**Responses to Requests for Additional Information from the Review of
WCAP-17483-P/WCAP-17483-NP, Revision 0, “Westinghouse Methodology
for Spent Fuel Pool and New Fuel Rack Criticality Analysis”
(Non-Proprietary)**

May 2015

Responses to 89 of the 109 RAI questions are provided in the following sections.

Figure 1: Fresh Fuel, Strong Absorbers k-eff Distribution.

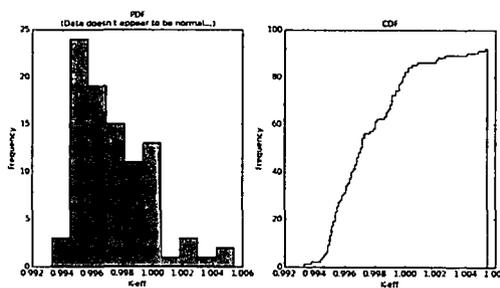
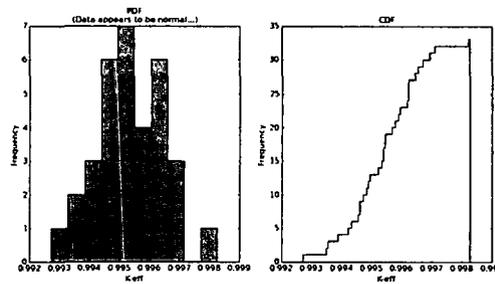
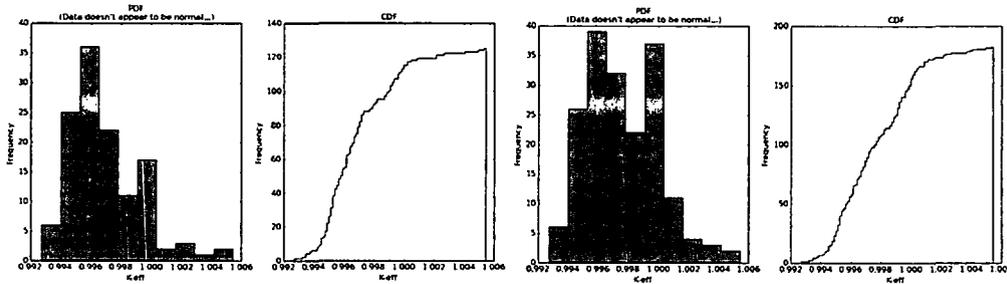
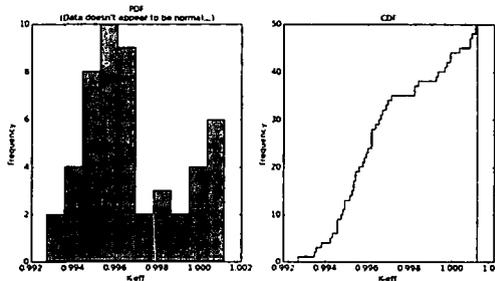
The NRC staff has performed independent confirmatory analysis to verify the results of Westinghouse's normality testing since many of the statistical formulations for calculating the bias and bias uncertainty rely on the assumption of data normality. NUREG-1475, Revision 1, "Applying Statistics," discusses the D'Agostino test for normality, which similar to the []^{a,c} test, is "considered an omnibus test for normality," but is only limited to sample sizes greater than approximately 20. Other applicable normality tests were also applied (i.e. the Lilliefors and Anderson-Darling tests).

The only validation set where independent normality testing is in agreement with Westinghouse is for the fresh fuel with no strong absorbers set; visual examination provides additional evidence that this data is likely to be normally distributed (see Figure 1). For all other validation sets, there is strong evidence that these sets are not likely to be normally distributed; again, visual examination provides additional evidence supporting this finding (see Figures 2 through 4). The only test that does indicate that these sets are normally distributed is the test used by Westinghouse, which is the []^{a,c} test, which is of relatively low statistical power (Reference: Comparisons of various types of normality tests, B. W. Yap, C. H. Sim, Journal of Statistical Computation and Simulation, Vol. 81, Iss. 12, 2011).

Revise the analysis in WCAP-17483-P/WCAP-17483-NP, Revision 0, to include a more robust data normality assessment.

The validation study provided in WCAP-17483-P/WCAP-17483-NP, Revision 0 was intended to provide a demonstration for performing a Monte-Carlo code validation and bias and bias uncertainty determination. Because plant-specific submittals will include a section on code validation, Sections 3.3.5 through 3.3.8 and Section 3.4 from WCAP-17483-P/WCAP-17483-NP Revision 0 will be removed.

Figure 1: KENO model of a fuel assembly with grids

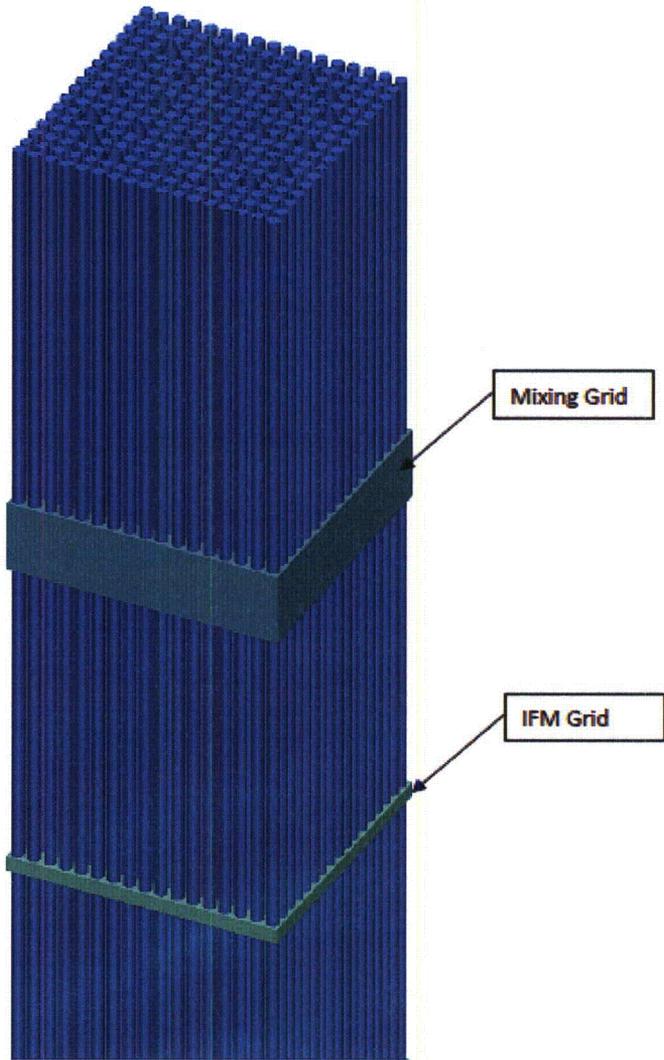
- a. *It appears that the intent of the studies presented in this section is to establish that it is conservative []^{a,c} If this was the intent, the study needs to be more extensive and more detail is required.*

- ii. Local burnup depressions created by the grids are not modeled in legacy core design studies. Modern methods, however capture these effects, which are inherently reflected within the plant-specific power and temperature profiles used in the criticality safety analysis.
- iii. [
